# IS-28B2/E0-25 MANDATORY SERVICE BULLETIN

PRODUCT : IS-28B2 GLIDER

SUBJECT : CHECK OF AIR BRAKE CONTROL HANDLES

**COMPLIANCE**: MODIFICATION RECORD CARD No. 28B2.07.1274

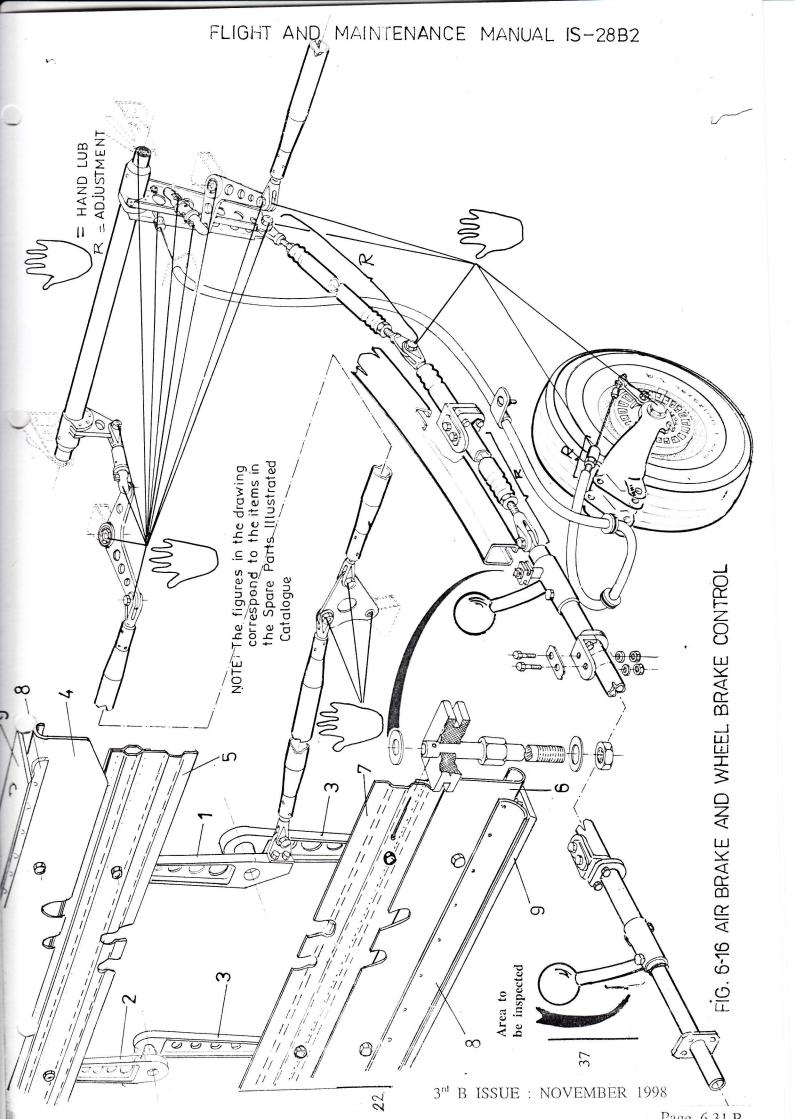
After every 100 flight hours, perform an inspection of the air brake control handles, welding and adjacent area (area shown in fig 6-16, page 6.31.B). Use a magnifier of minimum 1x10.

If any cracks are detected in the welding or adjacent area, stop the glider from flight and replace the two handles.

If any doubt exists, a penetrant dye may by used for crack detection.
